**Honor Our Pueblo Existence (H.O.P.E),  
Concerned Citizens for Nuclear Safety (CCNS), and  
Robert H. Gilkeson, Independent Registered Geologist**

August 20, 2013

***Re: Comments for the August 20, 2013 Meeting with the Defense Nuclear Facilities Safety Board in Santa Fe, New Mexico***

**Seismic Hazard Curves For Peak Horizontal Ground Motions From Simultaneous Ruptures From A Single Earthquake At the location of LANL PF-4, the RLUOB and the proposed CMRR-NF. Source: Figure 7 in the LANL 2009 PSHA Report.**

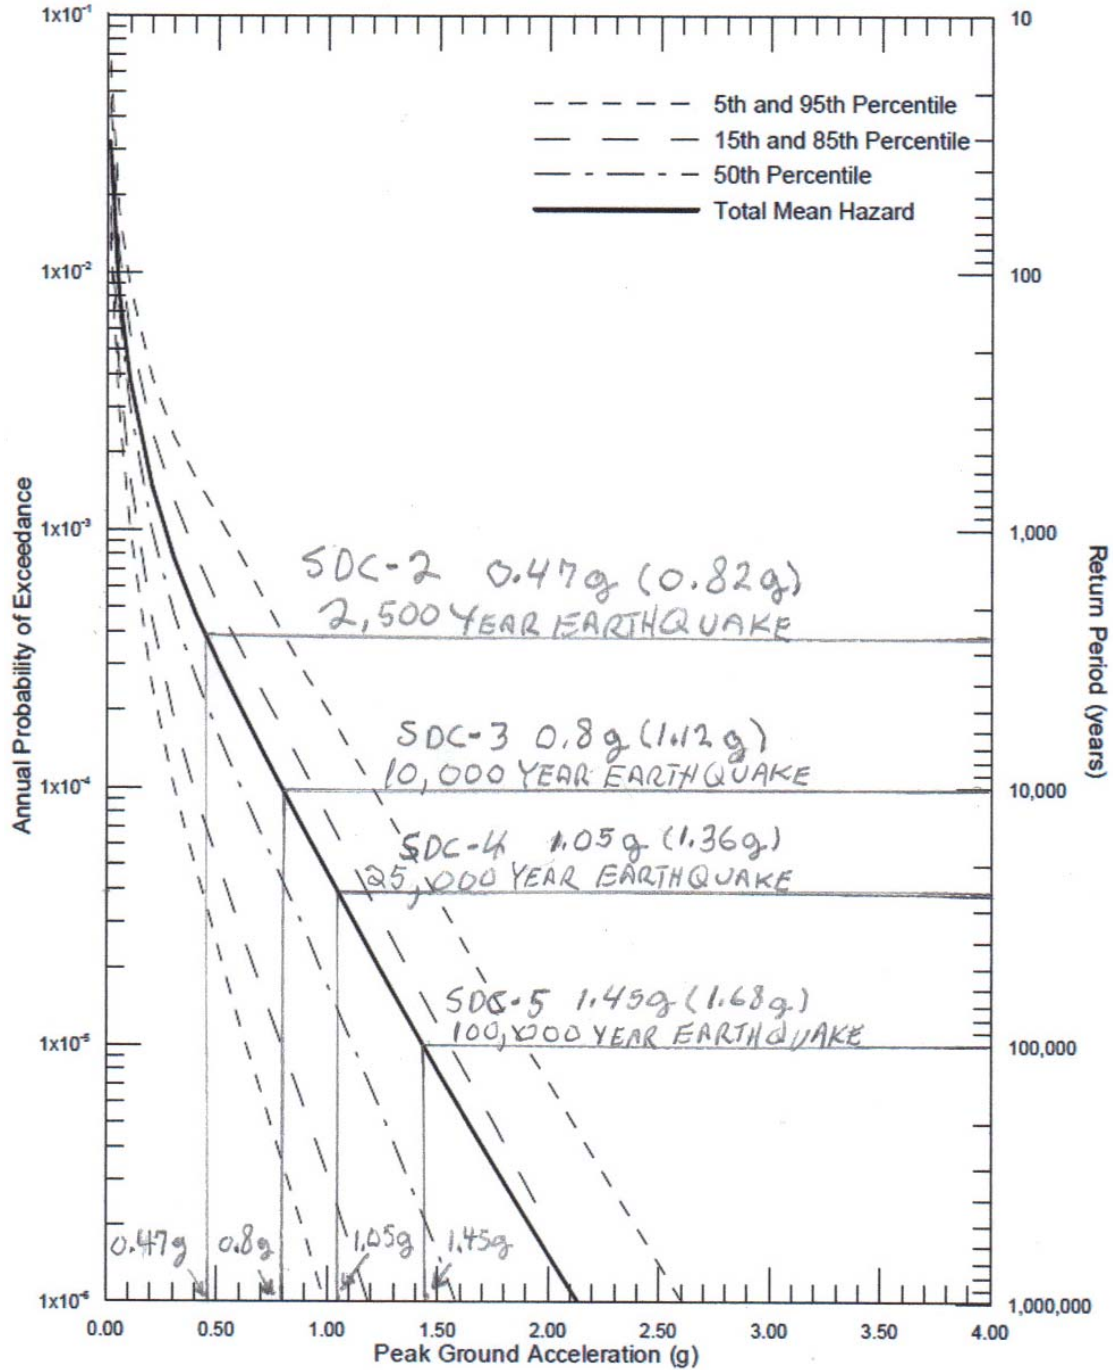
A graph of the large earthquake ground motions calculated in the LANL 2007 and 2009 Probabilistic Seismic Hazard Analysis (PSHA) Reports is attached to this report.

**Note:** The larger ground motions for synchronous earthquakes for each earthquake return period are in parentheses on the figure. The synchronous ground motions were calculated from Figure 8.
